Access Compliance Report

Public Rights-of-Way

(Curb Ramps)

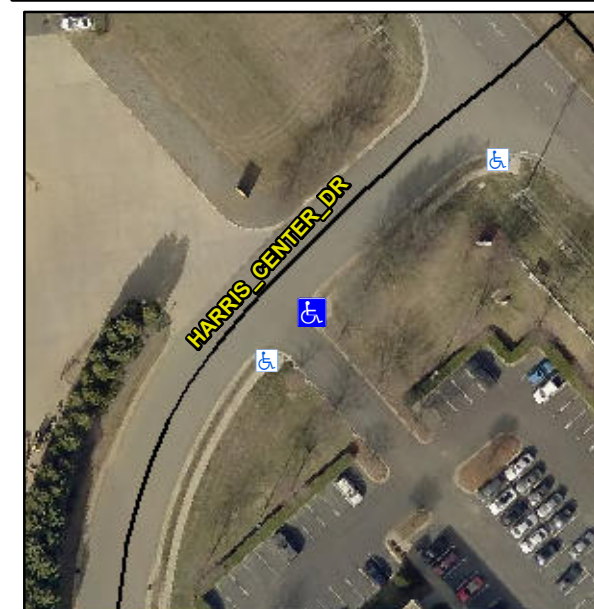
Not Found, R304.5.1, R304.2.2, R304.5.3

Compliance	Description	Data	Compliance	Description	Data
N/A	Ramp Length (in)	47.0	No	Ramp Slope (%)	9.9
No	Ramp Width (in)	34.0	No	Ramp XSlope (%)	11.1
N/A	Flare Type LT	N/A	N/A	Flare Type RT	N/A
N/A	Flare Slope LT (%)	N/A	N/A	Flare Slope RT (%)	N/A
N/A	Flare Traversable LT?	N/A	N/A	Flare Traversable RT?	N/A
N/A	Landing Length (in)	N/A	N/A	DWS Provided?	N/A
N/A	Landing Width (in)	N/A	N/A	DWS Contrast?	N/A
N/A	Landing Slope (%)	N/A	N/A	DWS Length (in)	N/A
N/A	Landing X Slope (%)	N/A	N/A	DWS Full Width?	N/A
N/A	Landing Curb? (Y/N)	N/A	N/A	DWS Offset (in)	N/A
N/A	Shared Landing?	N/A			
N/A	Gutter Ponding?	N/A	N/A	Gutter Slope (%)	N/A
N/A	Gutter Lip Ht (in)	N/A	N/A	Gutter X Slope (%)	N/A
N/A	Painted X Walk1?	No	N/A	Painted X Walk2?	N/A
	X Walk 1 Direction	To SW		X Walk 2 Direction	N/A
N/A	X Walk 1 Width (in)	N/A	N/A	X Walk 2 Width (in)	N/A
	X Walk 1 Slope (%)	4.8		X Walk 2 Slope (%)	N/A
	X Walk 1 X Slope (%)	7.9		X Walk 2 X Slope (%)	N/A

Remove & Replace Entire Ramp.
